Planning Commission Agenda

Site Plan Review

Site: 27300 Southfield Road
Applicant: Abro Property Group
Plan Date: September 18, 2023
Zoning: MX Mixed Use District
Parcel ID: 24-13-353-001
Proposal: Interior / Exterior Commercial Building Renovation

PROPOSED EXTERIOR AND INTERIOR RENOVATIONS
27300 SOUTHFIELD ROAD, LATHRUP VILLAGE, MI 48706
SITE AREA: 26,800 SQ. FT. (100' x 268') OR .615 AC

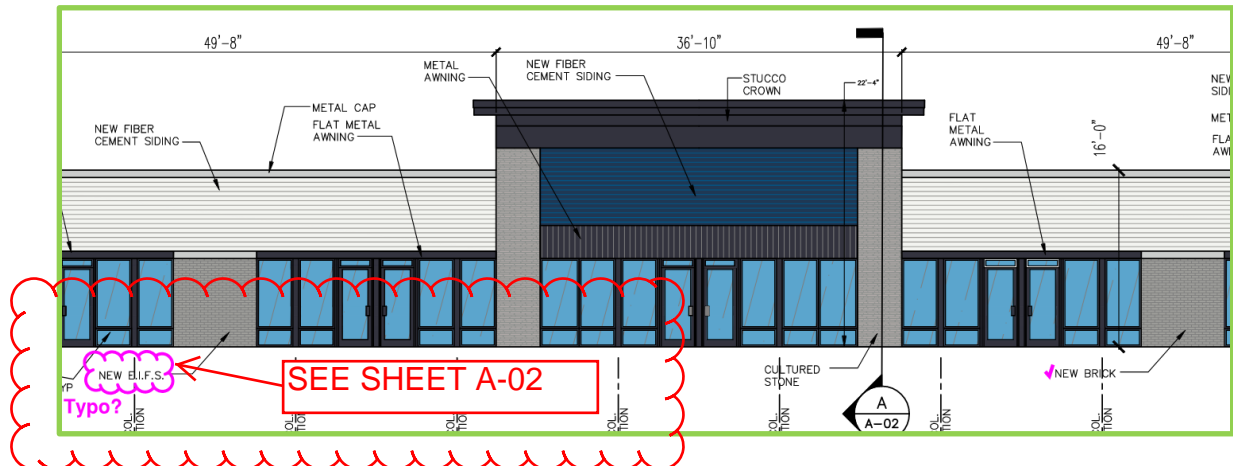
The updated elevations show changes to the building materials; however, **E.I.F.S. is still labeled in areas that may intend to be brick, as highlighted in the image below.** Fiber cement siding is used among much of the façade that is not accented by brick or cultured stone. Fiber cement is a masonry product designed to replace traditional wood and vinyl elements, but due to the higher sustainability it is often used in combination with or in place of traditional brick and stone.
